Re: MP07_0026 – Epiq Estate Lennox Head (Mod 7)

To assist the Department of Planning & Environment in reviewing our response to the submissions, the matters raised by the listed agencies are outlined within **Table 1** below, together with the proponent's response.

Table 1: Government Agency Submissions & Project Response

EPIQ ESTATE - LENNOX HEAD, NSW, 2478 SUPER LOT 5 CIVIL SERVICES PLAN	
Reference No. 2014/351	DRAWING No. 14351-S5-DA-CI-21
REVISION C

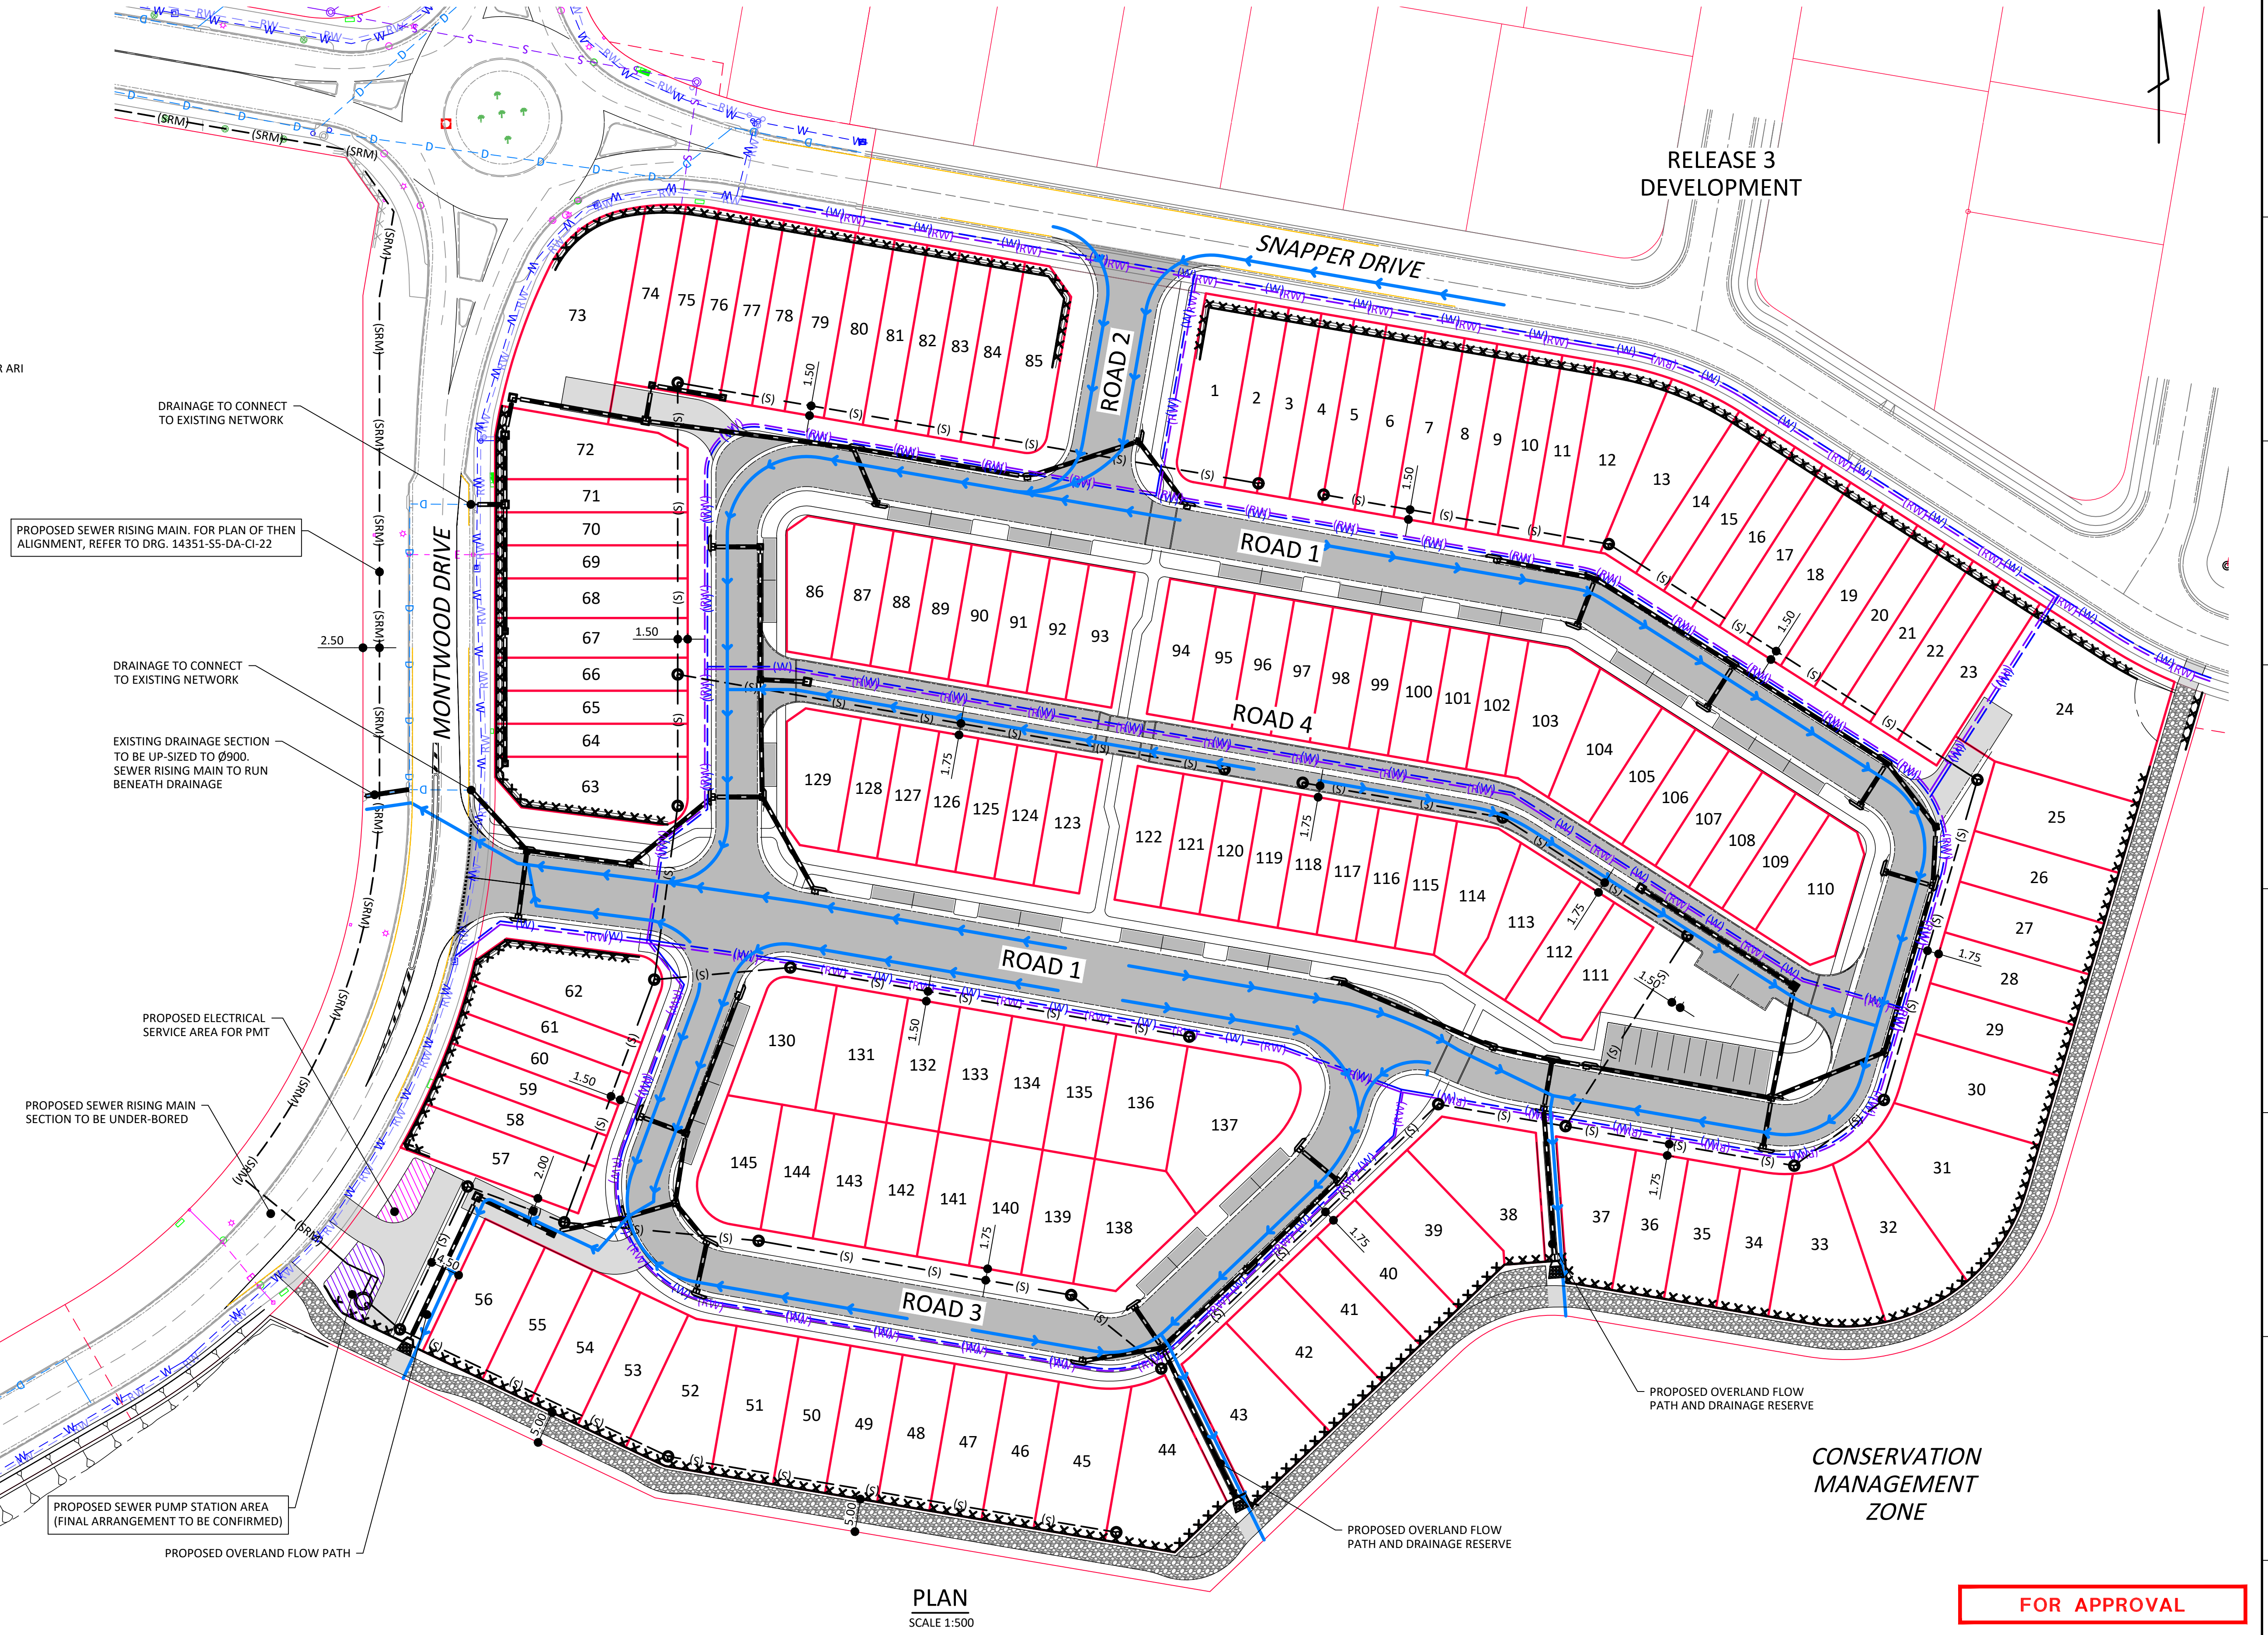
The information provided generally addresses Council's previous concerns in relation to this proposed modification. Accordingly, Council raises no objection to this modification as depicted in Plan of Drainage Works (Drawing No. 14351-S5-SK-DR-01 Rev B – dated 28.03.19) prepared by Newton Denny Chapelle, subject to suitable conditions being imposed by the Department of Planning and Environment and the following design changes being made prior to the issue of any approval.

Reference is made to the fact Drawing No. 14351-S5-SK-DR-01 Rev B has been updated to Rev C to incorporate the above recommendations of Ballina Shire Council and is provided within the design package contained within **Attachment 2** of this submission. The project design guidelines which also form part of the Modification have been updated to address the interface with the CMZ and associated APZ provisions (refer **Attachment 5**).
